March 12, 2000

It has come to our attention that Japan is proposing to adopt ECE 44.03 as a national standard. This would of course include the dynamic test as specified in Annex 7 Appendix 1 and 2 standards. These rules at present specify a decelerating trolley, and give acceleration pulse boundaries, specify impact velocity, and specify a stopping distance.

ECE 44.03 Annex 7 Appendix 1

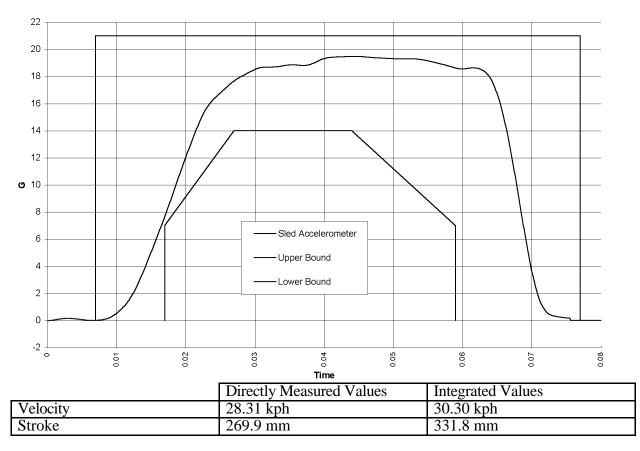
Directly Measured Values	Integrated Values
Velocity	48.91 kph	50.49 kph
Stroke	625.5 mm	665.7 mm

Although the pulse is comfortably within the limits when measured per the existing rule, it is not compliant when integrated values are used. The kinetic energy from the delta velocity is 6.6% higher than the impact kinetic energy.
